# UNITED STATES PATENT AND TRADEMARK OFFICE

APPLICATION NO.	FILING DATE	FIRST NAMED INVENTOR	ATTORNEY DOCKET NO.	CONFIRMATION NO.
09/898,385	07/05/2001	David Paul Jones	ESM00-003	3631

**Office Action Summary**

## **DETAILED ACTION**

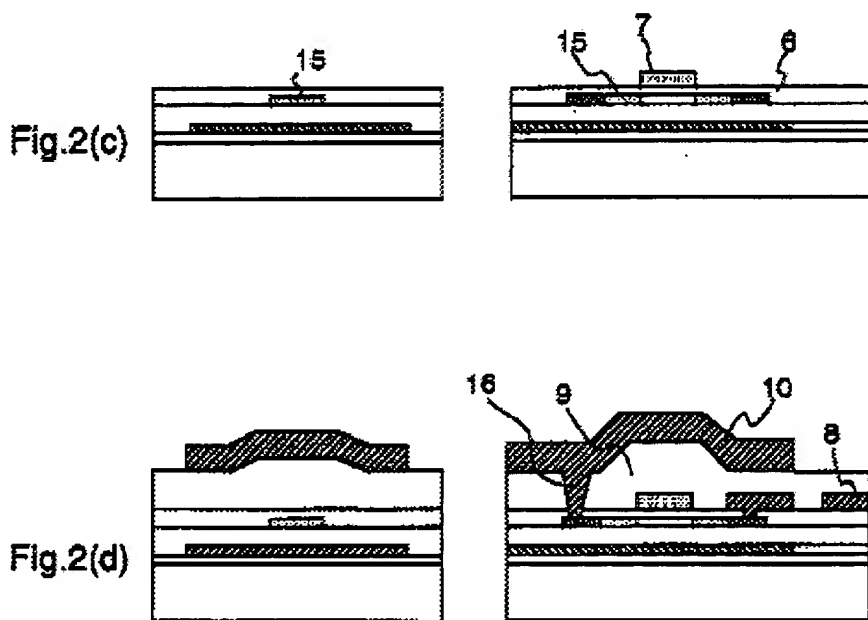
As to claim 1, Sera discloses in Example 1, Figures 1-2f, (col. 6 line 15, through col. 8, line 29 and col. 4, line 34 through col. 6, line 14) an optical element comprising: a transparent insulating substrate, 1; a gate line, 7 (Applicant's circuitry layer), on the insulating substrate; and an underneath light-shielding film, 3 (Applicant's opaque

optical shielding layer) (col. 6, lines 30-40), disposed to lie between the insulating substrate layer and the circuitry layer (per Figures 2a-2f).

Sera discloses the circuitry layer includes an active polysilicon layer, 5, (col. 7, lines 1-11) Sera discloses only a single opaque optical shielding layer, 3, serving as a black matrix body, is between the insulating substrate, 1, and the active polysilicon layer, 5, (per Figures 2a and 2b).

Sera discloses the optical element is part of a liquid crystal display and the opaque shielding layer also functions as a light shielding film (Applicant's black matrix) for said display (col. 6, lines 30-40).

Sera discloses the circuitry layer [stack of layers corresponding to Applicant's circuitry layer, 30, in Figure 3, per Applicant's specification, page 2, next to last paragraph] also includes additional layers that block light. However, Sera discloses no light blocking layers above said circuitry layer.

Please note that light may not leak between adjacent pixels of Sera in the region where light shielding layer, 3, is present. Please also note that claim 1 is not treated by Applicant as a true "consisting of" format claim, since Applicant modifies the claimed structure with dependent claims, however, examination was possible.

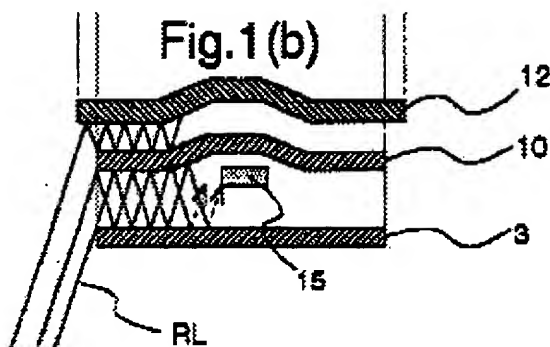
As to claim 24, Sera discloses the optical element of claim 1, wherein the optical shielding layer, 3, is comprised of a light reflective material as illustrated in Figure 1(b). Please note that the disclosed material of Sera is WSi that has a lower reflectance than

Al (col. 5, lines 9-16) and is therefore also an absorptive material (also reads on non-elected species, claim 25).

As to claims 26 and 27, Sera discloses in Figure 2(b) the optical element of claim 1, wherein the optical shielding layer is comprised of tungsten (WSi, Applicant's refractory metal) completely covered by itself (WSi, Applicant's encapsulated in a suitable barrier layer), (col. 6, lines 30-62). Please note that comprising format allows a solid material consisting of WSi to read on a claimed structure comprising W encapsulated in WSi.

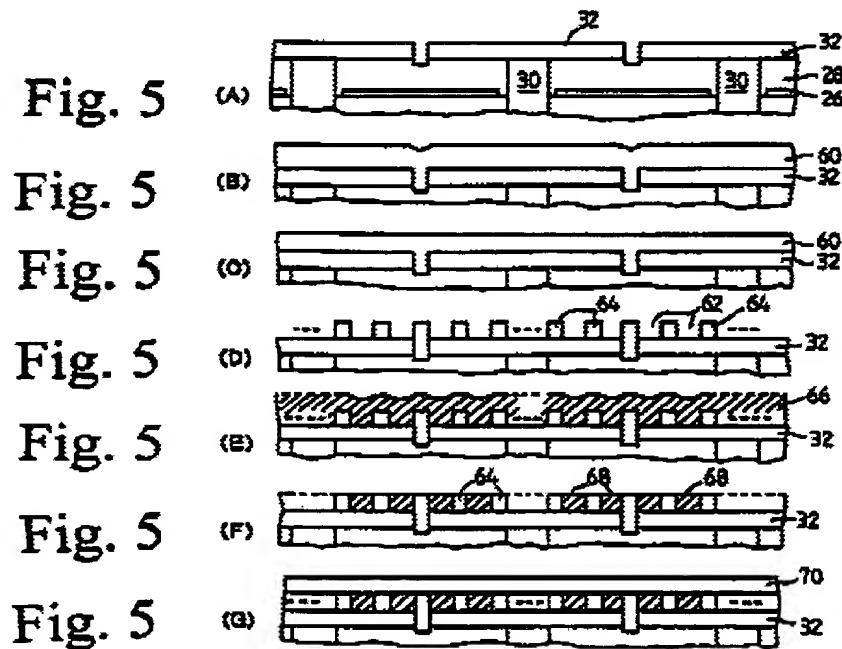
3. Claims 31 and 32 are rejected under 35 U.S.C. 103(a) as being unpatentable over Sera in view of Shinohara et al (Shinohara) USPAT 6,292,246 B1.

As to claims 31 and 32, Sera discloses the optical element of claim 26.

Sera does not explicitly disclose an element further comprising an adhesive layer disposed between the refractory metal and the transparent insulating substrate, wherein the adhesive is comprised of a titanium/titanium nitride laminate.

Shinohara teaches in Figures 5(a)-5(g) the use of an adhesive layer disposed between tungsten (Applicant's refractory metal) and the transparent insulating substrate, wherein the adhesive is comprised of a titanium/titanium nitride laminate under a layer comprising tungsten to provide improved adhesion to the underlying silicon dioxide layer (col. 5, lines 36-50).

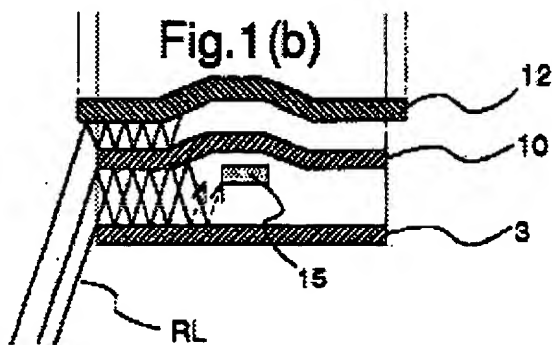
- (1) The presence of black matrix, 12, is contrary to claim 1.
- (2) Dependent claims are allowable since claim 1 is allowable.

(1) It is respectfully pointed out that Sera discloses the circuitry layer [stack of layers corresponding to Applicant's circuitry layer, 30, in Figure 3, per Applicant's specification, page 2, next to last paragraph] also includes additional layers 10 and 12 that block (reflect and/or absorb) light. However, Sera discloses no shield above said circuitry layer that functions to block the incident light from leaking between adjacent pixels, and Sera discloses only a single opaque optical shielding layer, 3, serving as a black matrix between the insulating substrate and the active polysilicon layer, per rejections above.

Please note that claims are presently in comprising type format. Please also note that negative limitations require particular support in the specification (e.g., presented as essential as opposed to optional), and negative limitations are often readily rejected under 35 U.S.C. 103(a).

In the interest of compact prosecution, Examiner respectfully recommends Applicant consider pursuit of an alternate approach to overcome applied Sera rather than merely correct the present ambiguity of claim language regarding Applicant's use of a single light blocking layer.
